Polaris Industries Inc.
Product Development Center
 7290 Viking Blvd E
 Wyoming, MN 55092
 T: 651-408-7579
 F: 651-408-7605
 January 6, 2016

RE: 579.5 Notices, bulletins, customer satisfaction campaigns, consumer advisories, and other communications for the month of December, 2015.

Manufacturer: Polaris Industries Inc. (Victory Motorcycle Division; Indian Motorcycle Company; Global Electric Motorcars (GEM), Slingshot)
 Report Author: Don L. Good
 Telephone Number: 651-408-7579

DECAL LOCATION

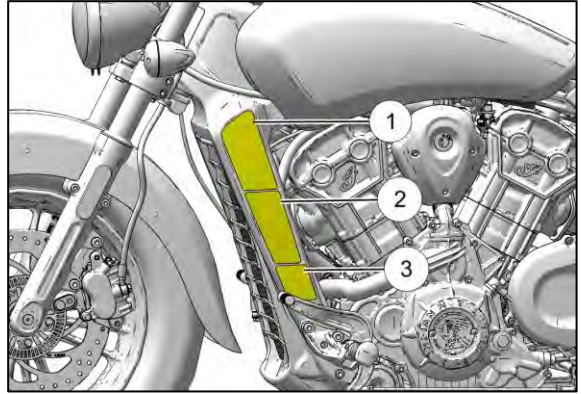
Indian Motorcycle has determined that 2016 Scout motorcycles, designated for sale in the US and Canada, were manufactured with a VECI decal that lists the valve clearance as “Self-Adjusting”. The engine used in Scout models utilizes a graded-bucket configuration, and valves should be inspected / adjusted every 20,000 miles (32,000 km). Indian Motorcycle has developed a replacement VECI decal to correct this error, which lists Intake and Exhaust valve clearance specifications as follows: (INTAKE: 0.152±0.050mm / EXHAUST: 0.203±0.050mm).

1. **49 State: Single VECI decal ① on LH radiator support. Replace decal with 7184386.**
2. **50 State: Single VECI decal ①. DO NOT REMOVE CARB DECAL ③.**
3. **CANADA: Two VECI decals English ① and French ②. Replace VECI decals ① with 7184386 and ② 7184388.**

1. Place motorcycle on side stand on a level surface. Allow motorcycle to warm to room temperature to ease decal removal. Working from the left side of the motorcycle, protect cosmetic surfaces and use a non-marring tool (PV-49955-2 or equivalent) to lift edge of VECI decal.

2. Slowly pull decal corner outward and up with even pressure to lift decal from frame.

3. Remove decal completely from front frame. Clean residual adhesive from the decal installation site with a decal adhesive cleaner (commercially available). Warm the replacement decal and motorcycle to room temperature. Install replacement decal in same orientation as the original decal. Air bubbles trapped beneath decal can be pressed toward edges to remove.

Seat Belt Installation:

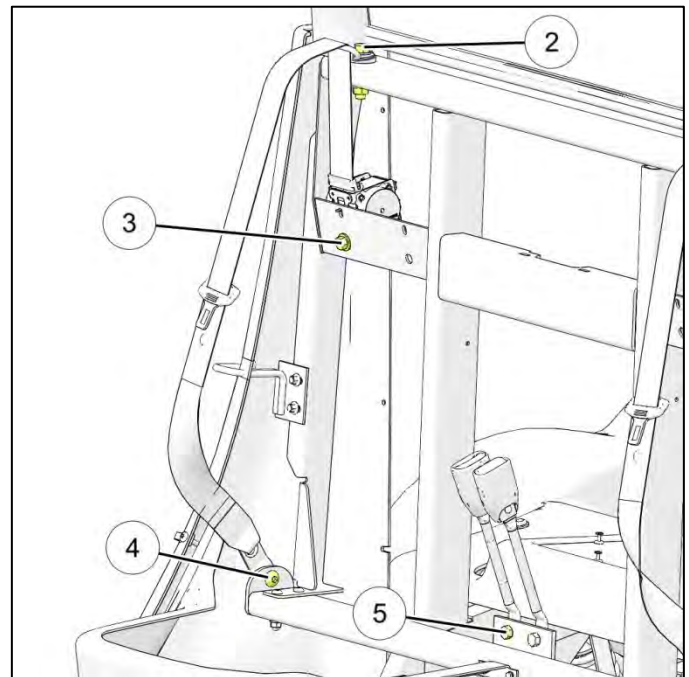
Some 2015 GEM vehicles were manufactured with seat belts that do not meet GEM quality standards. In some vehicles, the seat belt retraction mechanism could fail and not allow the seat belt to extend or retract properly. The result of such a condition could prevent the seat belts from being properly worn. The possible defect is limited to the GEM models in this bulletin; vehicles built from 12/17/2014 to 8/25/2015. Refer to Unit Inquiry to see if a vehicle is affected prior to performing this bulletin.

1. Attach D-ring to seat back support, making sure straight portion of D-ring faces forward. Tighten mounting bolt to 60 ft-lb.
 2. Attach seat belt/retractor assembly to seat back support. Tighten mounting bolt to 60 ft-lb.
- WARNING: TAB ON RETRACTOR ASSEMBLY MUST ENGAGE LOCATING HOLE ON SEAT BACK SUPPORT.**
3. Feed seat belt end through D-ring, back to front, and attach to flange at lower outboard end of seat back support. Tighten mounting bolt to 60 ft-lb.
 4. Install seat back assembly. Tighten fasteners to 9 ft-lb.
 5. Install lower seat cushion.
 6. Turn the master disconnect switch ON.

IDLE AIR CONTROL HOSE REPLACEMENT PROCEDURE:

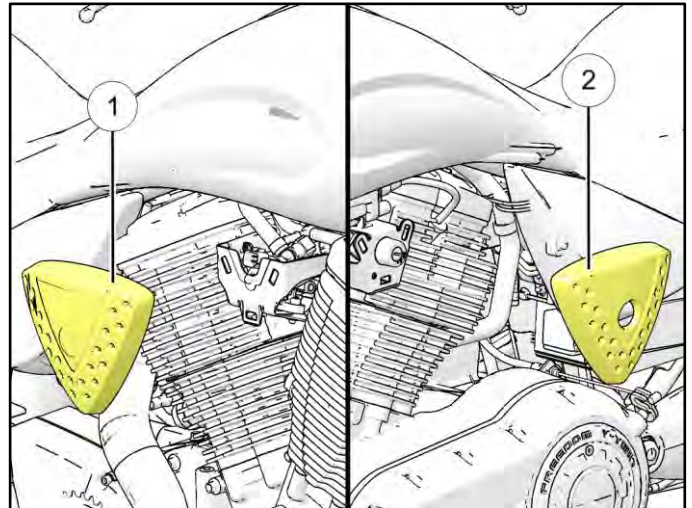
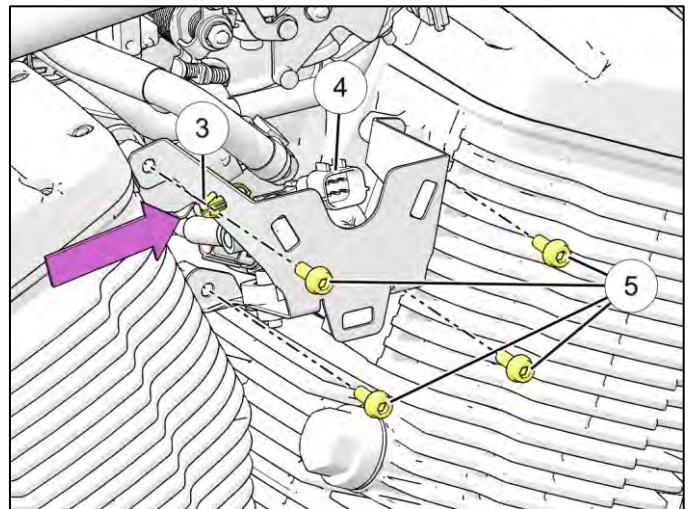
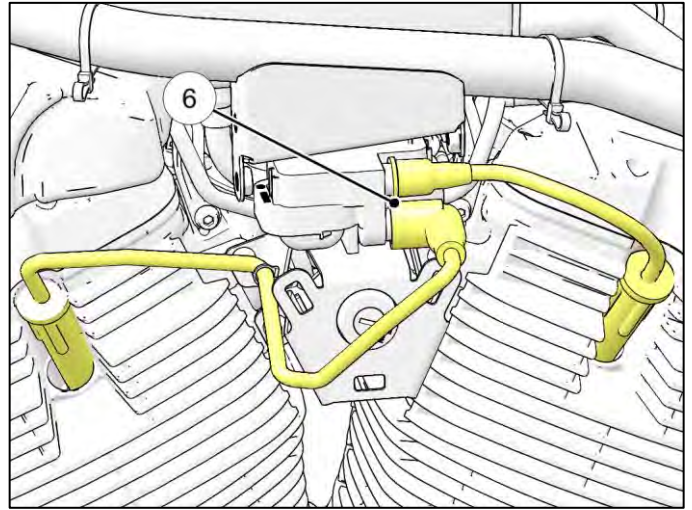
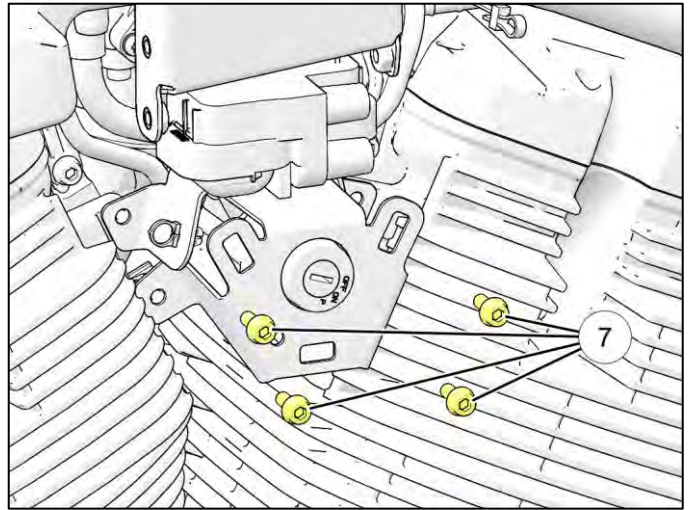
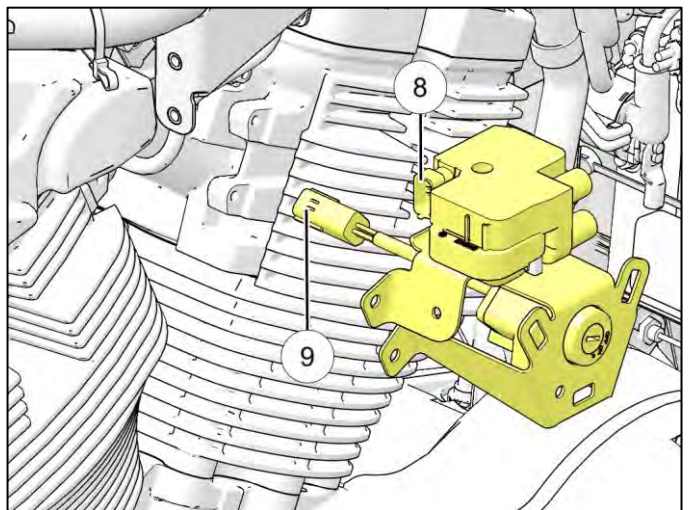
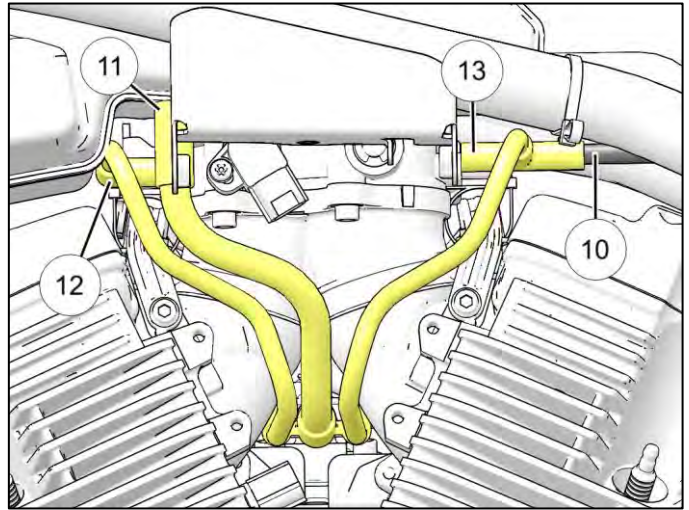
Victory has determined that some 2015 Victory motorcycle models, designated for sale in the State of California, may not meet emission control standards set forth by the California Air Resource Board (CARB). Some 2015 Victory motorcycles, equipped with California emission control components, may not effectively utilize stored fuel vapor from the charcoal canister. Victory has developed an updated Idle Air Control distribution hose which enables the engine to draw fuel vapor from the charcoal canister into both front and rear cylinders resulting in more complete utilization of stored fuel vapor. The ECM software must also be updated.

1. Place the motorcycle on a lift table with the front wheel clamped in a wheel vise.
2. Remove the IAC cover (1) and Ignition Switch cover (2).
3. **ALL MODELS EXCEPT VISION:** Remove fuel tank as outlined in service manual.

4. Remove the wire dart (3) by squeezing the end of the clip and pushing to the inside of the IAC cover bracket.
5. Disconnect the IAC harness connector from IAC receptacle (4).
6. Remove IAC bracket screws (5) using a 5mm ball-drive hex wrench.
7. Using a flat head screwdriver, press the three rubber hose fittings off of the IAC module and remove the bracket and IAC as an assembly.

8. Remove high-tension leads (HTL) from coil ⑥.

9. Remove Ignition Switch bracket screws ⑦ using a 5mm ball-drive hex wrench.

10. Disconnect the primary wire harness from coil ⑧ and ignition switch connector ⑨.

11. Remove the coil, switch and bracket as an assembly.
